EXHIBIT G

PUBLIC COMMENT

**AUDREY ESTATES NEIGHBORHOOD MEETING – SEPTEMBER 21, 2022
5:30PM – 6:30 PM, POULSBO FIRE DEPARTMENT (911 LIBERTY ROAD)**

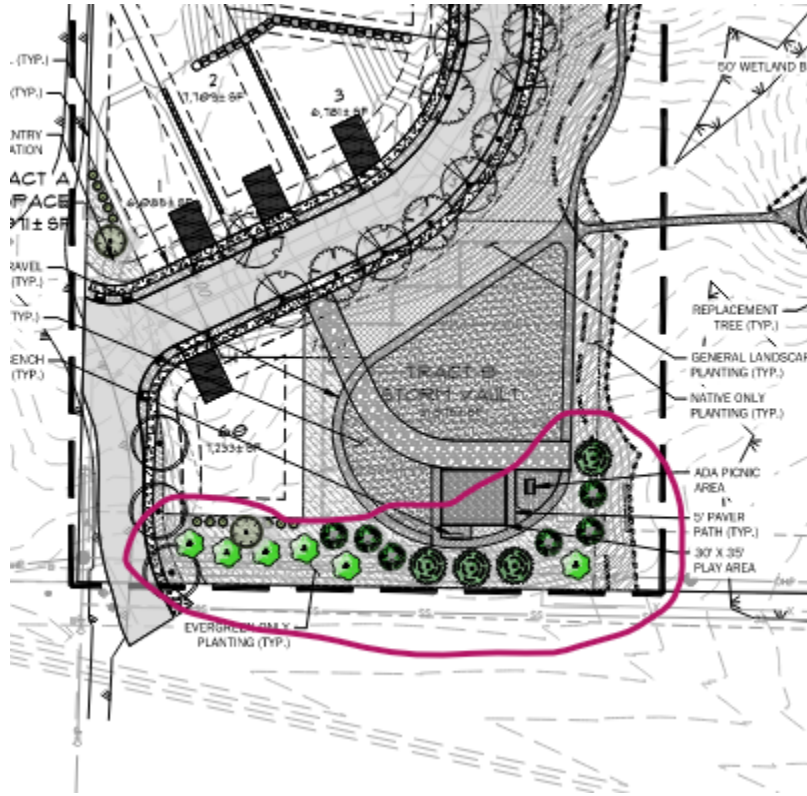
- The storm vault is going to cut off the wildlife corridor, suggests a tree cover.

Members of the applicant's team have met with Melinda Wedgewood to further discuss disruption of existing wildlife routes on the subject property and surrounding parcels. Approximately 11 acres of the 25.18-acre site will not be disturbed. Of this area, approximately 8.53 acres comprise a wetland and stream system with associated buffers which are tributary to Bjorgen Creek.

The undisturbed area will accommodate some wildlife corridor. Tree cover is proposed to be retained to the maximum extent possible along the eastern and southern edges of the project as well as within some wetland areas internal to the site. In areas where tree cover will be impacted along this boundary additional trees are proposed as replacement trees (circled areas below).

In addition, tree cover is proposed along the south edge of the vault that will connect to existing vegetation to remain within the Wetland A buffer.

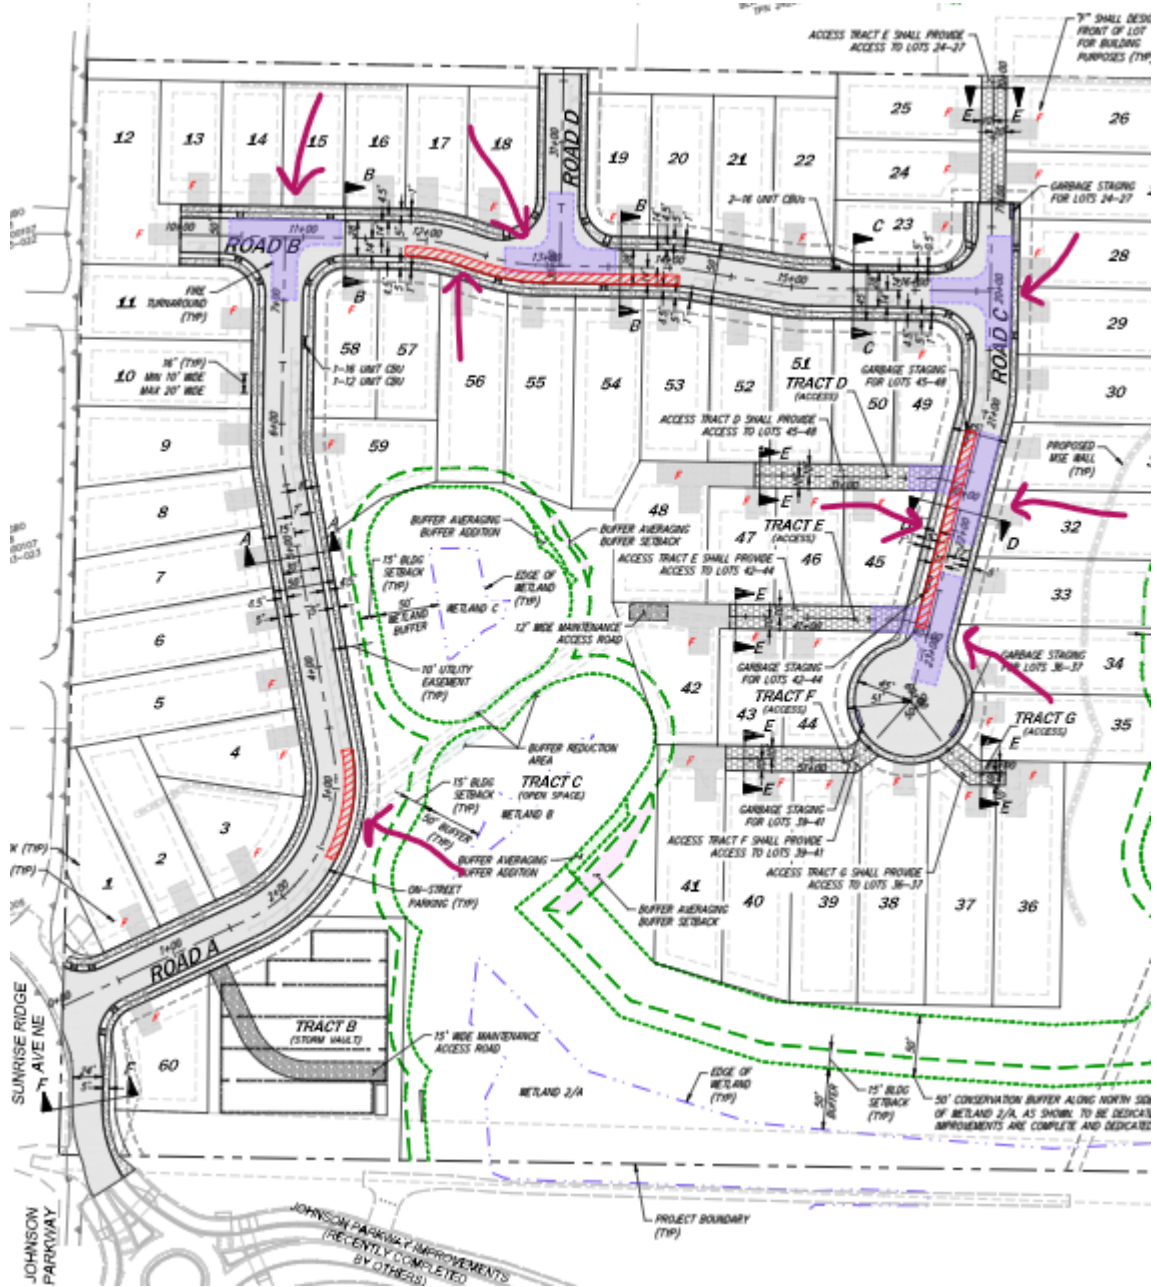
- Will there be a fence around this?

Fencing is not currently proposed.
